**APPLICATION OF APACHE CORPORATION
FOR AN ADJUDICATORY HEARING TO
CONTEST THE DIVISION'S CONDITIONS OF
APPROVAL ON APACHE CORPORATION'S
SCOPE OF WORK FOR ADDITIONAL
INVESTIGATION, LEA COUNTY, NEW MEXICO**

CASE NO. 24912

**APACHE CORPORATION AND THE OIL CONSERVATION DIVISION'S JOINT
MOTION TO AMEND ORDER NO. R-23728**

Exhibit A: Modified Final Conditions of Approval

Proposed Monitoring Wells
EBDU 37 32.4807053, -103.123085 Apache Corporation Eunice, Lea County, New Mexico

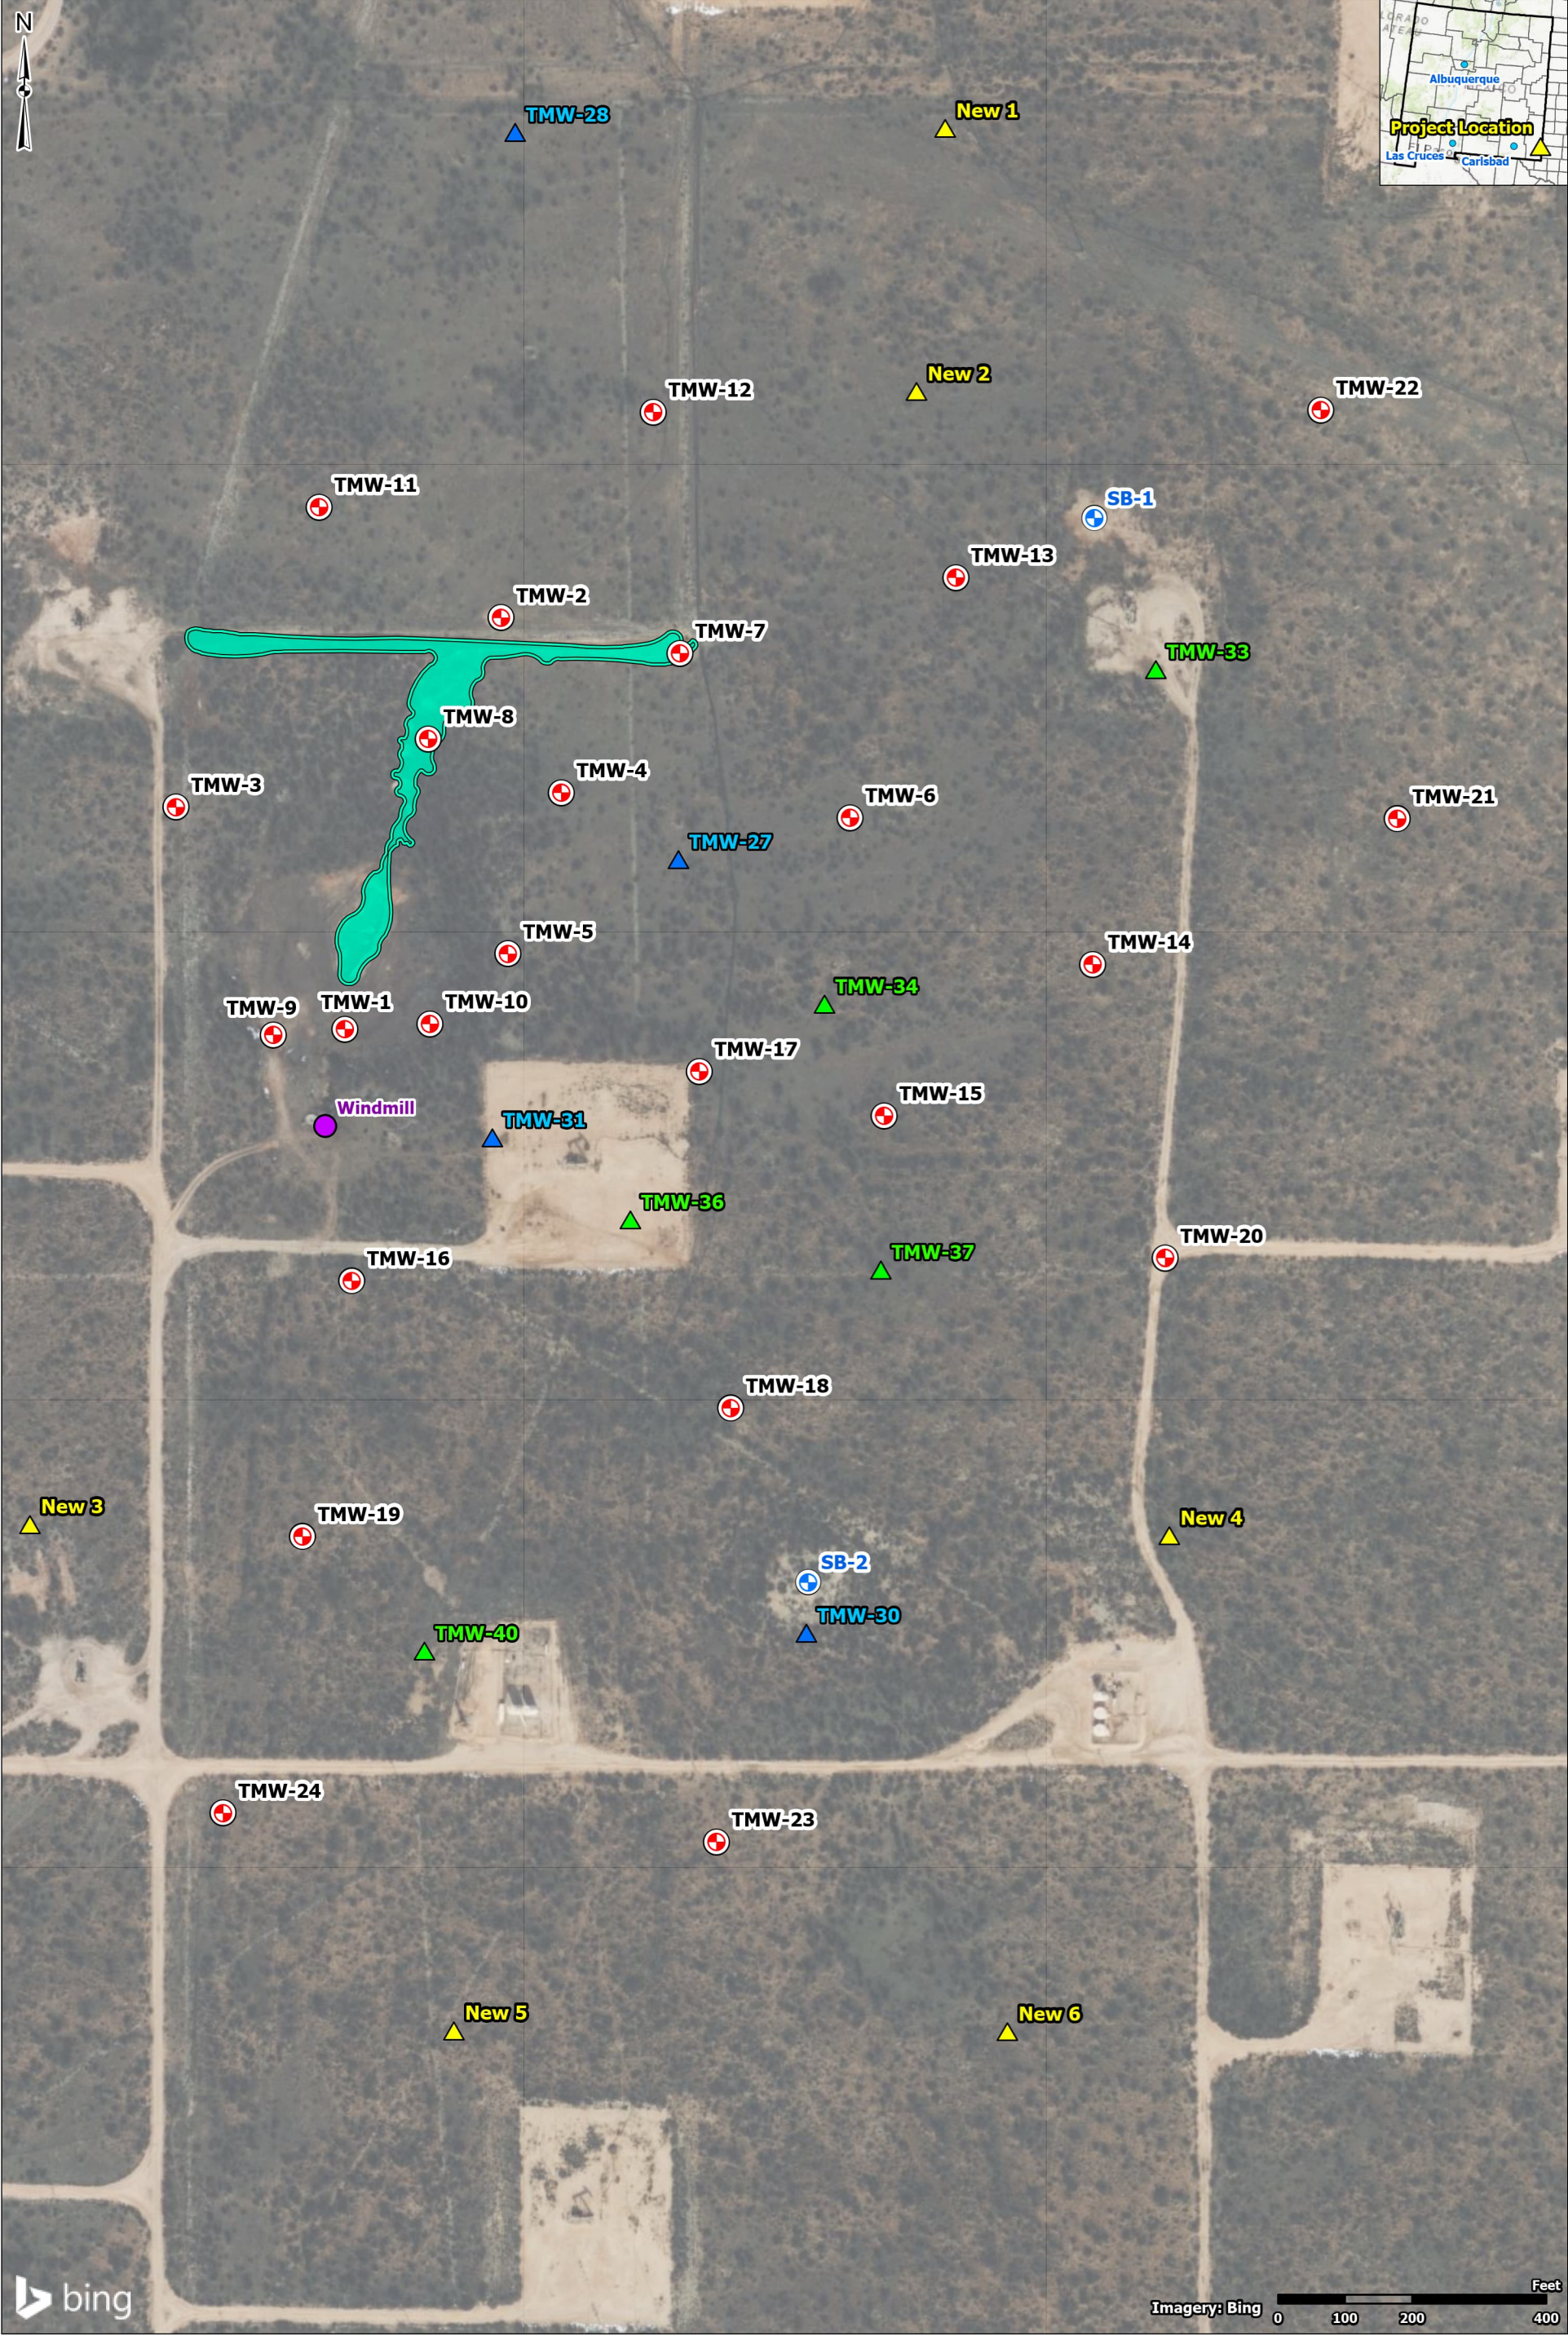
6. The six “New” well locations relate to the following wells as specified in Order Ex. A: “New 1” (32.4825050°, -103.119588°) is a modification (approximately 100 feet east) of the well identified as TMW-30 in Order Ex. A and is moved to better define background conditions; “New 2” (32.481600°, -103.119705°) is a modification (approximately 150 feet east) of the well identified as TMW-32 in Order Ex. A and is moved to reduce the distance between adjacent wells for more precise characterization; “New 3” (32.477701°, -103.123321°) is a modification (approximately 150 feet west) of the well required in Condition 6 of Order Ex. A to provide delineation of the plume boundary to the west of well TMW-19); “New 4” (32.477662°, -103.118673°) is a modification (approximately 250 feet southeast) of the well identified as TMW-38 in the Order Ex. A and is to provide characterization in the southeast part of the site; “New 5” (32.475958°, -103.121591°) is a modification (approximately 200 feet south) of the well identified as TMW-41 in Order Ex. A and is to provide characterization at the southern extent of the release area; and “New 6” (32.475825°, -103.119373°) is a modification (approximately 200 feet southeast) of first of the two wells identified as TMW-42 in Order Ex. A and is to provide downgradient characterization at the southeastern extent of the release area. Generally, the purpose of these six wells is to define the perimeter of the plume.

<u>Order Ex. A</u>	<u>Modified Conditions</u>
1a: TMW-30	New 1
1b: same as Condition 5	TMW-31
1c: TMW-32	New 2
1d: TMW-33	TMW-33 with modified location
1e: TMW-34	No change
1f: TMW-35	Omitted
1g: TMW-36	No change
1h: TMW-37	No change
1i: TMW-38	New 4
1j: TMW-40	No change
1k: TMW-41	New 5
1l: TMW-42	New 6
1m: TMW-42	Omitted
5: ½ way between TMW-17 and windmill	TMW-31 (same as 1b)
6: 200' west of TMW-19	New 3

Apache agreed that soil borings will be drilled in these locations, as described in Exhibit A hereto. Soil borings will enable evaluation of the soil column without creating a potential conduit to the groundwater. TMW-42 (condition 1m) will not be installed given the presence of existing TMW-13, proposed well New 2, and proposed well TMW-13. TMW-30 will be installed approximately 70 feet south of the location for the boring in this location.

- j. New 1 (32.482505°, -103.119588°) This is a modification (approximately 100 feet east) of the OCD final order well TMW-30. Better defines background concentrations.

- k. New 2 (32.481600°, -103.119705°) This is a modification (approximately 100 feet northeast) of the OCD final order well TMW-32. Reduces distance between adjacent wells for more precise characterization.

- l. New 3 (32.477701°, -103.123321°) This is a modification (approximately 150 feet west) of the well requested in Condition 6 of the OCD final order well. Provides delineation west of TMW-19.

- m. New 4 (32.477662°, -103.118673°) This is a modification (approximately 250 feet east) of the OCD final order well TMW-38. Better defines background concentrations. Provides characterization in the southeast of the site.

- n. New 5 (32.475958°, -103.121591°) This is a modification (approximately 200 feet south) of the OCD final order well TMW-41. Provides downgradient characterization at the southern extent of the release area.

- o. New 6 (32.475825°, -103.119373°) This is a modification (approximately 200 feet southeast) of the OCD final order well TMW-42 (condition 11). Provides downgradient characterization at the southeastern extent of the release area.

2. Soil borings:
- a. SB-1 (32.481164°, -103.118979°) This boring is proposed in a location approximately 180 feet northeast of existing monitoring well TMW-13. The boring is located centered on an area with restricted vegetation growth suspected of being a potential source of contaminants leaching to groundwater.

- b. SB-2 (32.477502°, -103.120147°) This boring is proposed approximately 230 feet southeast of existing TMW-18. The boring is located centered on an area with restricted vegetation growth suspected of being a potential source of contaminants leaching to groundwater.
